Access Compliance Report

Public Rights-of-Way

(Curb Ramps)

Intersection ID: 32314	Main Street: CAMDEN TRAIL CT	Cross Street: NEW PROVIDENCE LN	Location: SE
ADA ID: 1D9A610E910A	Ramp Type: Perp	Initial Pass/Fail: Fail	Overall Compliance: No
Codes/Mitigation Info/Possible Solution		Field Measurements/Component Compliance	
Severity Score: 21.25

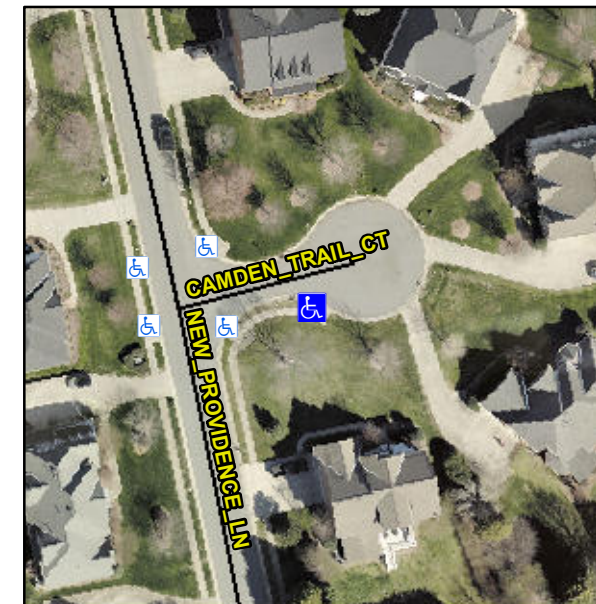
Not Found, R304.5.1, R304.2.2

Compliance	Description	Data	Compliance	Description	Data
N/A	Ramp Length (in)	48.0	No	Ramp Slope (%)	8.5
No	Ramp Width (in)	42.0	Yes	Ramp XSlope (%)	1.9
N/A	Flare Type LT	N/A	N/A	Flare Type RT	N/A
N/A	Flare Slope LT (%)	N/A	N/A	Flare Slope RT (%)	N/A
N/A	Flare Traversable LT?	N/A	N/A	Flare Traversable RT?	N/A
N/A	Landing Length (in)	N/A	N/A	DWS Provided?	N/A
N/A	Landing Width (in)	N/A	N/A	DWS Contrast?	N/A
N/A	Landing Slope (%)	N/A	N/A	DWS Length (in)	N/A
N/A	Landing X Slope (%)	N/A	N/A	DWS Full Width?	N/A
N/A	Landing Curb? (Y/N)	N/A	N/A	DWS Offset (in)	N/A
N/A	Shared Landing?	N/A			
N/A	Gutter Ponding?	N/A	N/A	Gutter Slope (%)	N/A
N/A	Gutter Lip Ht (in)	N/A	N/A	Gutter X Slope (%)	N/A
N/A	Painted X Walk1?	No	N/A	Painted X Walk2?	N/A
	X Walk 1 Direction	To N		X Walk 2 Direction	N/A
N/A	X Walk 1 Width (in)	N/A	N/A	X Walk 2 Width (in)	N/A
	X Walk 1 Slope (%)	1.7		X Walk 2 Slope (%)	N/A
	X Walk 1 X Slope (%)	6.1		X Walk 2 X Slope (%)	N/A

Remove & Replace Entire Ramp.
